TEREX TELELECT

Product Advisory

PA-1007-02

SUBJECT: Aerial Lift Performance

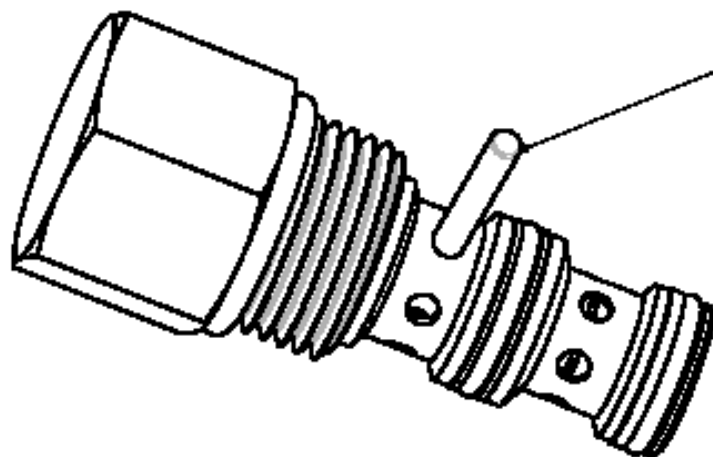
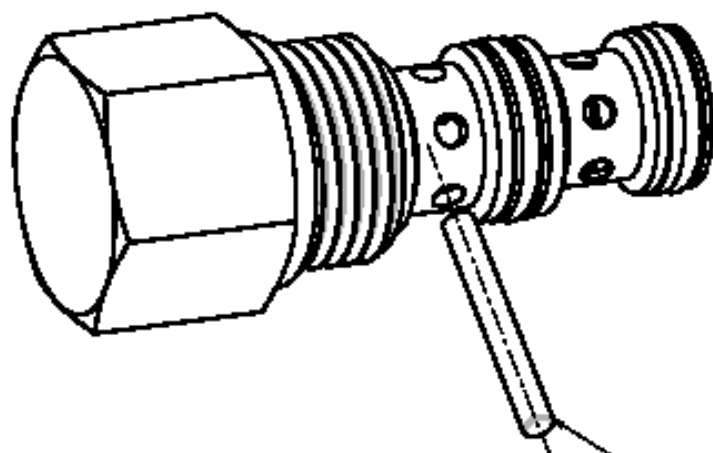
Owners of T292 and TL36/38P units may increase the boom speeds of their units by increasing the flow to the upper control valve. The hydraulic flow is regulated by a fixed priority flow control located in the upper control valve. (See illustration below). The priority flow control valve, on units built prior to December 17th, 2001, was fixed to deliver 2.5 GPM of hydraulic oil to the boom functions. This has been changed to deliver 3 GPM. The existing flow control may be easily modified to increase the flow to 3 GPM, (Provided the hydraulic pump is capable of delivering 3GPM under load), by drilling the orifice (.106 diameter) in the nose of the cartridge as illustrated on the following page. In addition, the system pressure may be increased to 2650 PSI. It is permissible to increase the system relief and stamp the identification placard, located on the unit tower, to the updated system pressure. The owner will be responsible for the product improvement.

innorek CORPORATION		TITLE		DATE		TYP		REV	
FLOW CONTROL MODIFICATION		12/19/01		1.500		A		9914502	
DRAWN BY: JAS		CHECKED BY: JAS		DATE: 12/19/01		TYP: 1.500		REV: 0	
SCALE: 1:1		PART NO: 9914502		REV: 0		A		9914502	
REV: 0		A		9914502		REV: 0		9914502

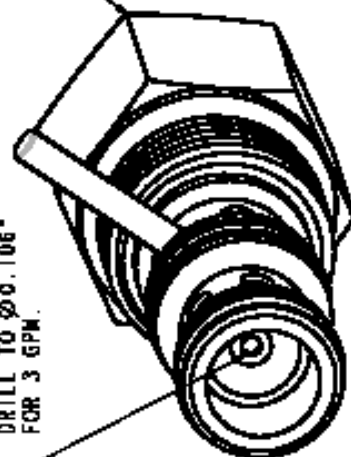
ORIFICE LOCATION
DRILL TO Ø0.106"
FOR 3 GPM.
